Subject: Submission - DA 2023/0225

REF: DA2023/0225-891 Pittwater Road, Collaroy. 2097.

I refer to the above Development Application and hereby offer this **Submission of Objection** in respect to this application.

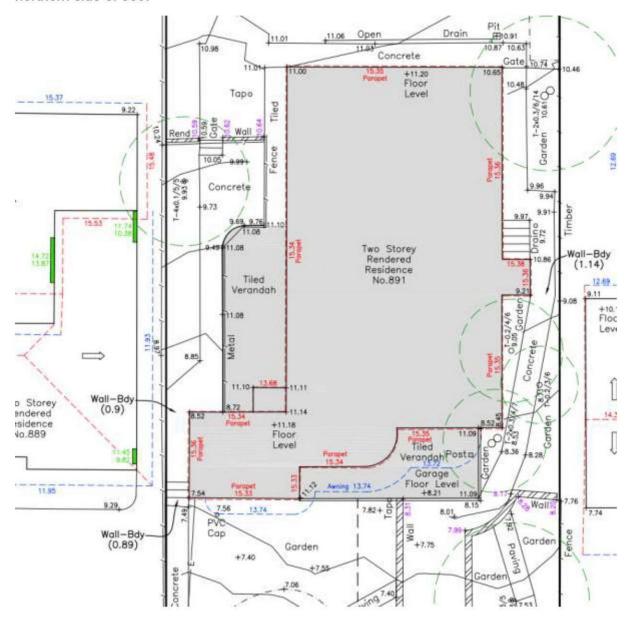
The proposed development plan seeks to increase the height of the dwelling even further to a height of 9.19m exceeding the 8.5m height limit. This is a variation from the LEP height control of 690mm extending for approximately 45% for the length of the roof.

By the inclusion of the third storey this increases the wall heights to Control 7.2m, provided 8.3m. which is in excess of the control height of 7.2 metres which is 1.1 metres higher and considered to be unreasonable.

It is noted that this proposed construction exceeds the neighbouring buildings by approx. 2m (2091mm and 1971mm) which will also have the effect of blocking further solar access.
